STATE OF MAINE DEPARTMENT OF TRANSPORTATION 16 STATE HOUSE STATION AUGUSTA, MAINE 04333-0016

September 17, 2010 Subject: **Brunswick** Federal Project No: 015236.00 State Pin No: 015236.00

Amendment No. 2

State of Maine Department of Transportation Portland North Track and Drainage Improvements

Drainage Trench Detail

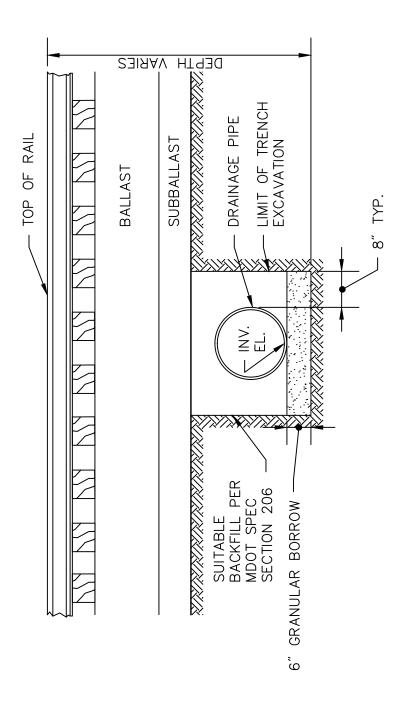
Question: Could the Department provide a typical section for D.I.P. drain crossings to verify backfill materials?

Response: A sketch is provided to show a typical section.
